Ōhoka Residential Subdivision Expert Panel Chair

9 October 2026

Ōhoka FTAA – Stormwater Review

Figure 1: Typical cross-section

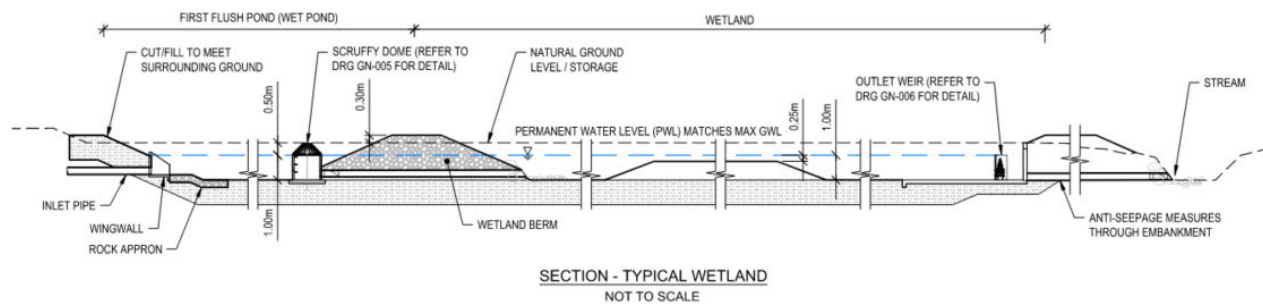
42. The Stormwater Management Report states the first flush basins are designed to capture the runoff from 25 mm of rainfall and slowly release it over four days to the wetland, with two days' hydraulic residence time in the wetland (as per Christchurch City Council's Waterways, Wetlands and Drainage Guide).

- Relative timing and effects on storage volume**
43. The attenuation storage would need to fill and drain down much more rapidly to limit the peak flows discharged in larger events. The Stormwater Management Report notes that the attenuation volume would be discharged in less than 24 hours. My alternative calculations (refer item 49) suggest that it could be in the order of a few hours.

44. If the first flush volume takes a number of days to drain down, then that storage volume is occupied during that time and is not available to provide the faster response attenuation storage. If this is not accounted for the design, this would lead to the attenuation function not performing as intended.

45. Understanding this difference in timing for the storage and release of the first flush treatment volume and attenuation volume is important for design of the stormwater management areas in terms of their arrangement, outlet control structures and total storage volumes.

46. The water level in the first flush basin will sit above the permanent water level for a period of time following any rainfall event, and for four days following a rainfall of 25 mm or larger. This means the first flush basin will be partially full much of the time. This reduces the storage volume available for peak flow

attenuation if the event is larger than a first flush event or if there is a subsequent rainfall event. This does not appear to have been allowed for in the design.

- 47. If the storage is already full or partially full when the design storm arrives, the system would not perform as intended. It would reduce the live storage available in the stormwater management devices, increasing the peak water levels in the stormwater management devices (and the upstream stormwater system) and increasing the discharge from the devices. The increased peak flow discharged could be higher than the pre-development peak flow.
